National
Association
of Home
Builders

International Energy Code Suggested Amendments

2018 International Energy Conservation Code

2013 ASHRAE Handbook—Fundamentals

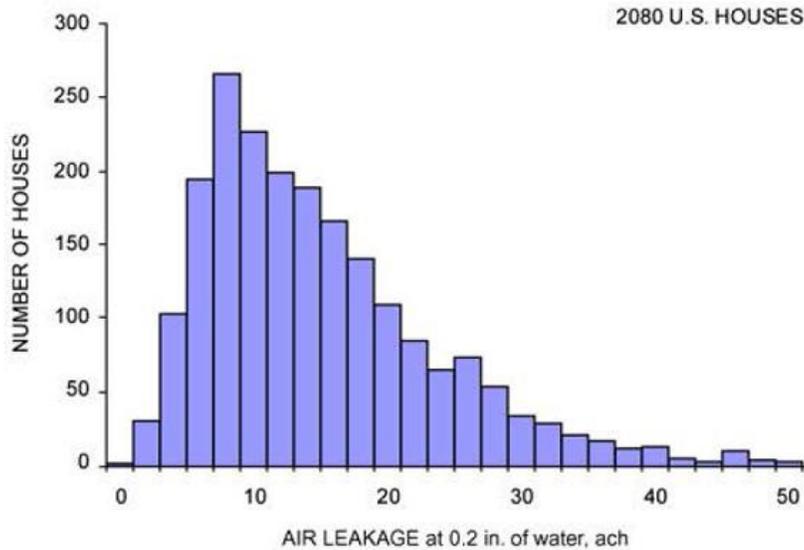
Building tightness is an important part of an energy-efficient and comfortable house. However, 3 air changes (ACH) per hour at 50 Pascals is an extremely low target tightness, especially for smaller homes. The ASHRAE Handbook of Fundamentals shows that around 8% of U.S. homes achieve 3 ACH or less, 13% achieve 4 and less than 23% achieve 5. The proposed 5 ACH while still an aggressive tightness level will provide a tight, comfortable, energy-efficient home.
